Recall Information Bulletin

No: C10118 **Issued:** 6/14/2021

Re: Vacuum Pump

Safety Recall C10118 – Vacuum Pump

Modification Procedure

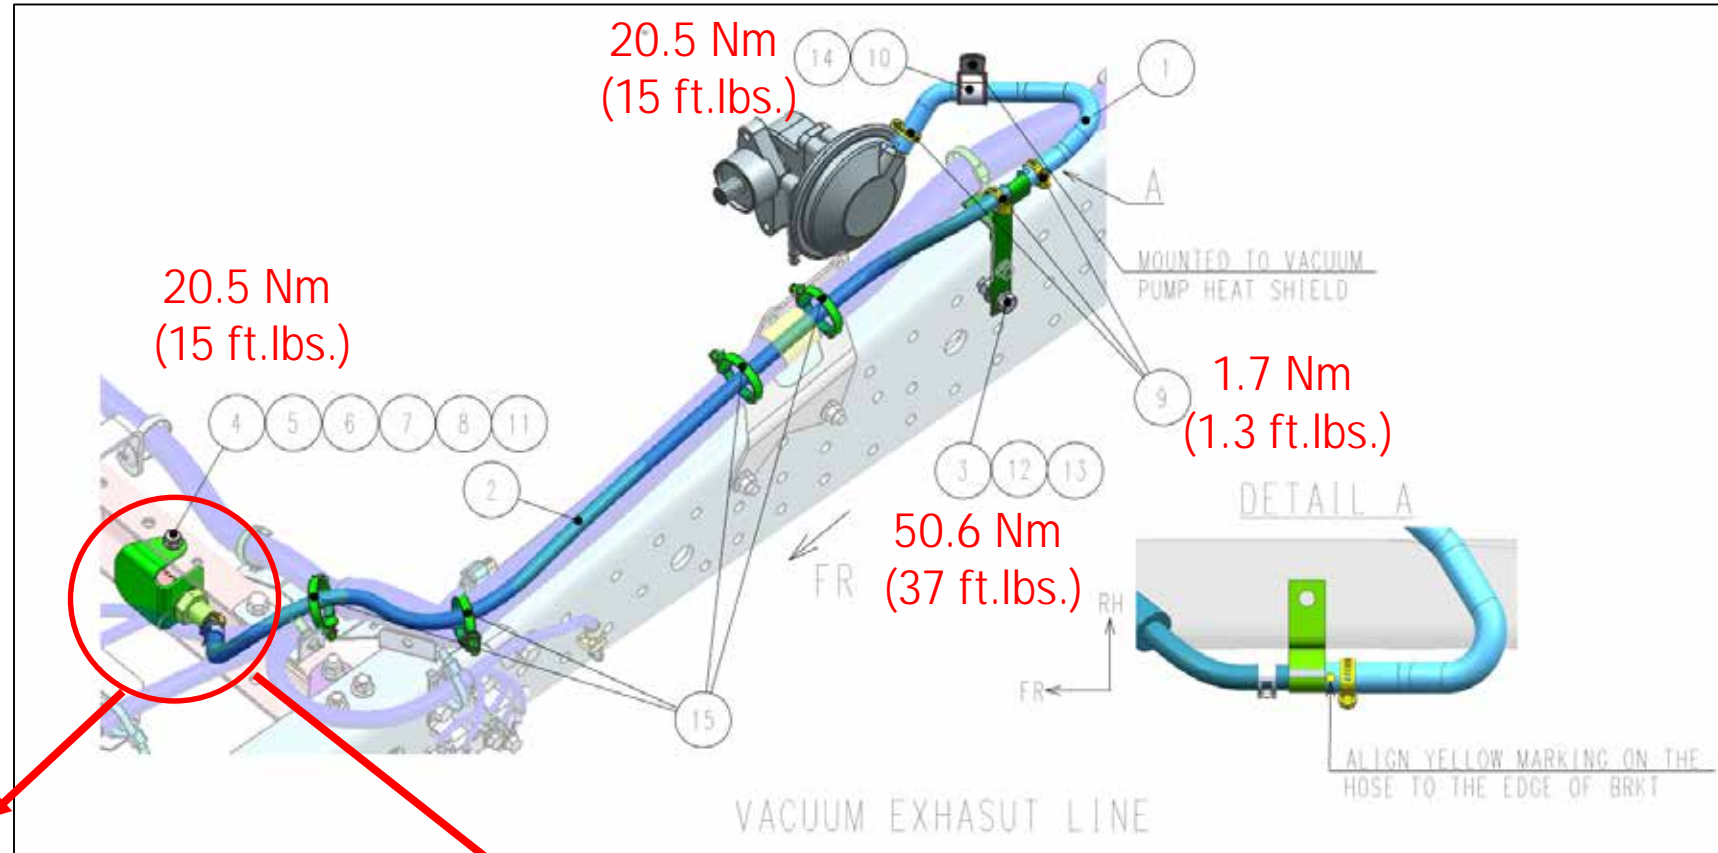
1. Reroute vacuum exhaust line.

Prevent bracket rotation by holding weld nut (15) on bracket with a wrench while tightening the bolt

Connector inlet angle ;
0~30 degrees.

Angle 0 degrees case

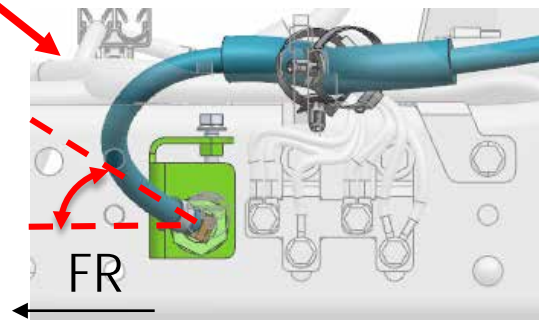
2. Reconnect the existing vacuum inlet hose (bottom position).

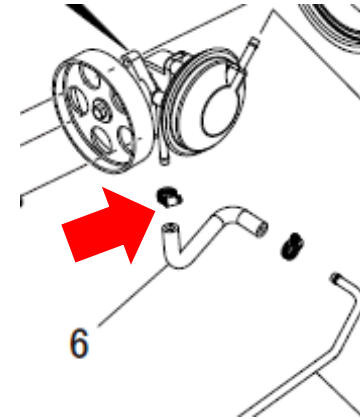
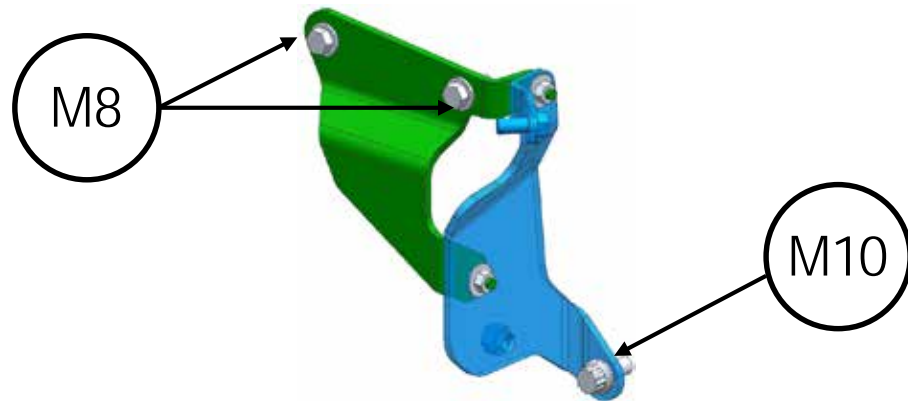
3. Assemble bracket and shield (M6, 5.2 ft.lbs.).

4. Connect the new vacuum exhaust hose through the shield and bracket before affixing it to the engine.

6. 1st tighten the bracket (M8, 11 ft.lbs.)
2nd tighten the shield (M10, 35.4 ft.lbs.)
- Check the clearance between the pump cover and shield (next page).

Clearance between pump cover and heat shield

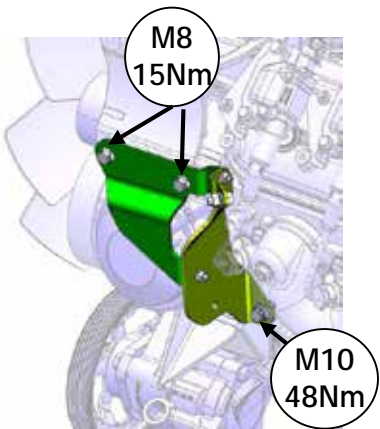
Clearance check on DMU=> 5mm

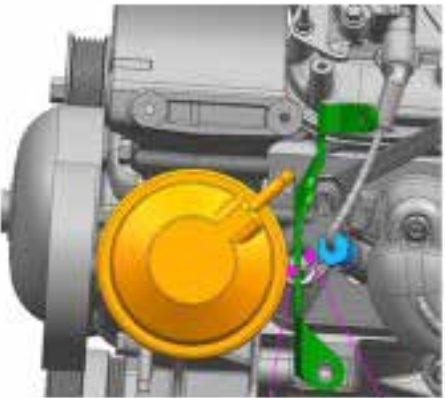
GOOD (about 5 mm clearance), tighten M8 with the bracket flush against the engine A/C boss

Flush

Check clearance with tool (driver about 5mm)

NO GOOD (insufficient clearance), when M10 is tightened first

Not flush

Too narrow (less than 5mm)
